Parkside Village Homeowners Association  
P.O. Box 777  
Crozet, VA 22932

October 29, 2020

Subject: Special Use Permit SP202000016 for Claudius Crozet Park

Figure 2. Elevated view showing sight lines originating from the proposed permanent entrance (Drawing by Collins Engineering).

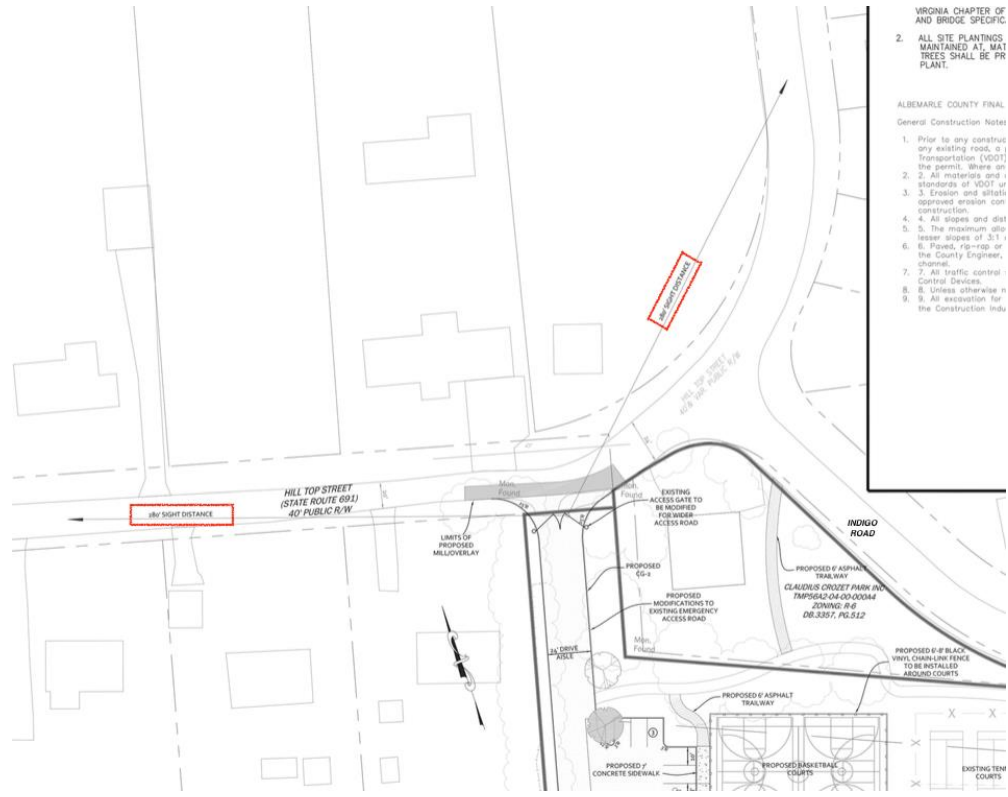
Our Association has several concerns that we would appreciate being taken into consideration when determining the permanent future of this access point. We do not believe that the VDOT minimum 280 ft sight distance is met in either direction from a vehicle on the access road (see Figure 2). To the left (west), trees on private lots and cars parked on driveways block this sightline. To the center-right (northeast), the steep grade of Hill Top Street obscures oncoming traffic from this vantage point and is a concern that is challenging to discern from maps alone (see Figure 3). We believe this creates a dangerous intersection in a neighborhood heavily trafficked by pedestrians and children at play.

**We respectfully request that conversion of the emergency access road to a permanent park entrance not be granted.**
